Access Compliance Report

Public Rights-of-Way (Curb Ramps)

Intersection ID: 47449	Main Street: MALLARD_LANDING_RD	Cross Street: WOOD_DUCK_CROSSING_DR	Location: NW
ADA ID: 0A87CCF0ED82	Ramp Type: Perp	Initial Pass/Fail: Fail	Overall Compliance: No Severity Score: 21.25

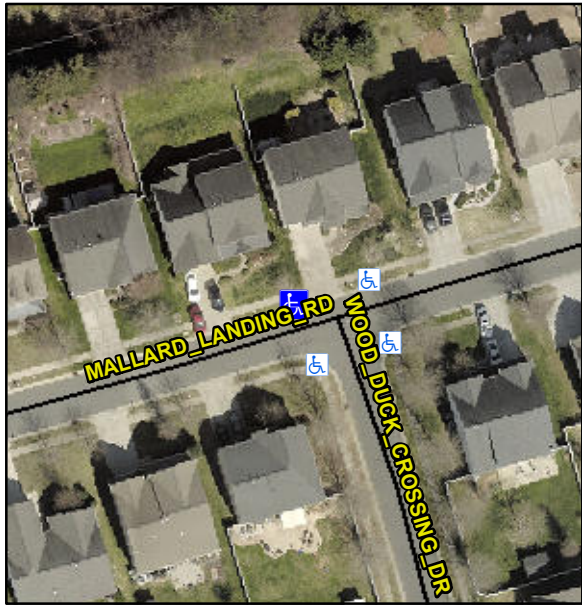
Codes/Mitigation Info/Possible Solution			Field Measurements/Component Compliance					
	Possible Solutions:		Compliance	Description	Data	Compliance	Description	Data
	Remove & Replace Entire Ramp.		N/A	Ramp Length (in)	47.3	No	Ramp Slope (%)	9.7
			No	Ramp Width (in)	47.5	Yes	Ramp XSlope (%)	1.9
			N/A	Flare Type LT	N/A	N/A	Flare Type RT	N/A
			N/A	Flare Slope LT (%)	N/A	N/A	Flare Slope RT (%)	N/A
			N/A	Flare Traversable LT?	N/A	N/A	Flare Traversable RT?	N/A
			N/A	Landing Length (in)	N/A	N/A	DWS Provided?	N/A
			N/A	Landing Width (in)	N/A	N/A	DWS Contrast?	N/A
			N/A	Landing Slope (%)	N/A	N/A	DWS Length (in)	N/A
			N/A	Landing X Slope (%)	N/A	N/A	DWS Full Width?	N/A
<p>Surveyor Notes:</p> <p>N/A</p> <p>PROW/ADA:</p> <p>Not Found, R304.5.1, R304.2.2</p>			N/A	Landing Curb? (Y/N)	N/A	N/A	DWS Offset (in)	N/A
			N/A	Shared Landing?	N/A			
			N/A	Gutter Ponding?	N/A	N/A	Gutter Slope (%)	N/A
			N/A	Gutter Lip Ht (in)	N/A	N/A	Gutter X Slope (%)	N/A

N/A	Painted X Walk1?	No	N/A	Painted X Walk2?	N/A
				X Walk 1 Direction	To S		X Walk 2 Direction	N/A
			N/A	X Walk 1 Width (in)	N/A	N/A	X Walk 2 Width (in)	N/A
				X Walk 1 Slope (%)	1.7		X Walk 2 Slope (%)	N/A
				X Walk 1 X Slope (%)	2.3		X Walk 2 X Slope (%)	N/A
			N/A	Ramp inside XWalk1?	N/A	N/A	Ramp inside XWalk2?	N/A
<p>Street 1 Name</p> <p>Stop Condition-Street 2</p> <p>Street 2 Name</p> <p>Stop Condition-Street 1</p>				Road Slope (%)	N/A	N/A	Clear Space?	N/A
				Road X Slope (%)	N/A	N/A	Clear Space to XWalk (in)	N/A
			N/A	Any Obstructions?	N/A	N/A	Storm Grate/Utility Hazard?	N/A
				Obstruction Type			Storm Grate/Utility Type	
						N/A		N/A
						Yes	Surface Condition? (G/P)	Good
Total Cost:		\$	1850.00
